URGENT WELD BULLETIN

Cottrell, Inc. has received reports that there has been some confusion on the SB006 bottom gusset welding procedures on the C-10LTA and C-10LTB trailers. Please see photos below of examples of the correct and incorrect weld procedure for this area. Picture A shows the correct weld procedure for welding the top of the gusset to the front post. Picture B demonstrates an improper installation with a weld missing at the top of the gusset, and also demonstrates improper wrapping of the weld at the corner of the gusset. Attached is a drawing showing the correct welding procedures and weld locations. If you currently own a C-10LTA or C-10LTB trailer, or if you have performed the SB006 update on a customer's C-10LTA or C-10LTB trailer please inspect immediately. If not properly welded, please contact Kris Ransom at 800-827-0132 ext 301 for a resolution.

PICTURE 'B'

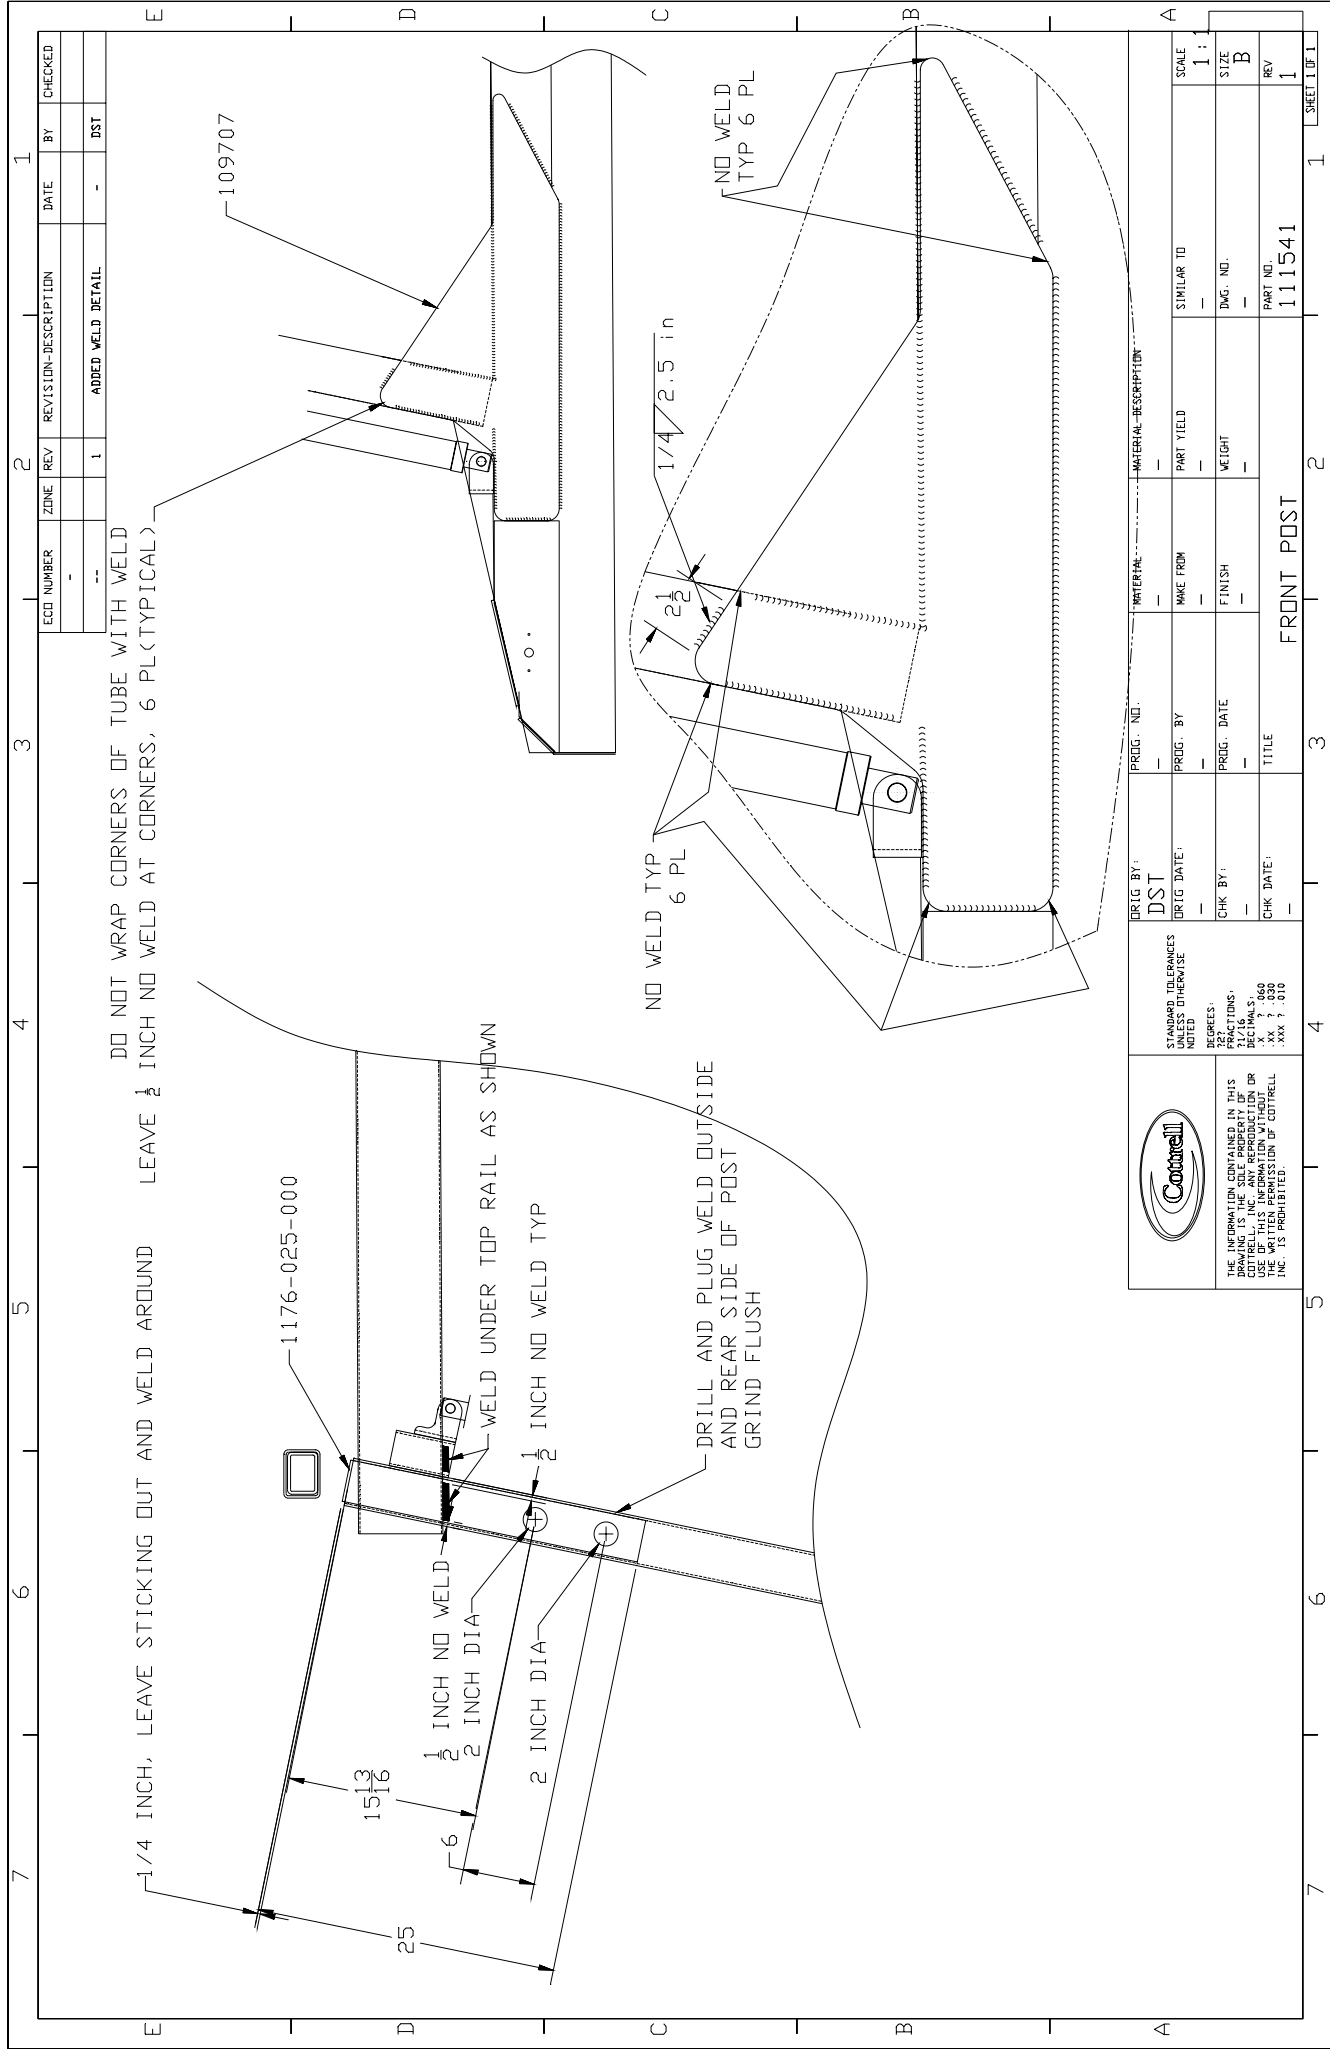
INCORRECT

- No weld at top of gusset
- Weld wrapping corner of gusset

CORRECT

- 2 1/2" weld at top of gusset
- No wrapping of welds in corners

Review following drawing, #111541, for correct welding specifications and procedures.
